City of Mississauga

City Department and Agency Comments

Date Finalized: 2024-11-21 File(s): A344.24

Property Address: 165 Preston Meadow Ave

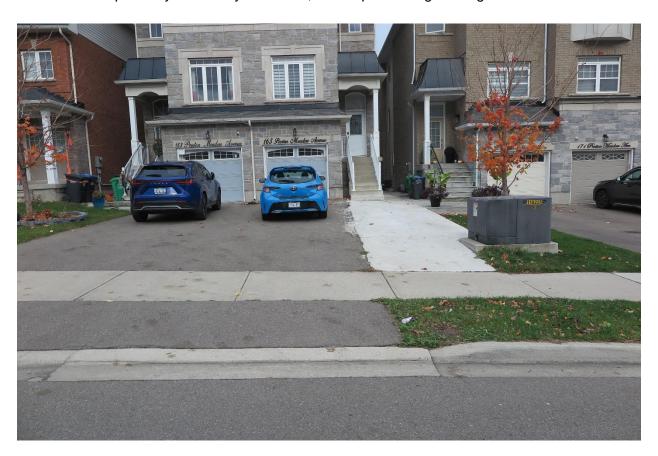
Enclosed for Committees easy reference are some recent photos depicting the existing driveway. In our previous comments we indicated that the driveway was expanded in very close proximity to the hydro transformer and that any driveway was to be a minimum of 1.5M away from any utility. From the revised sketch drawing received by the Committee (dated October 3, 2024) a 1.5M setback is being proposed and the area around the hydro transformer depicts a shaded green area (grass).

Provided that the 1.5M setback is maintained from the utility and that the hard surface area around the hydro transformer be re-instated with topsoil and sod, we would have no objections to the request.
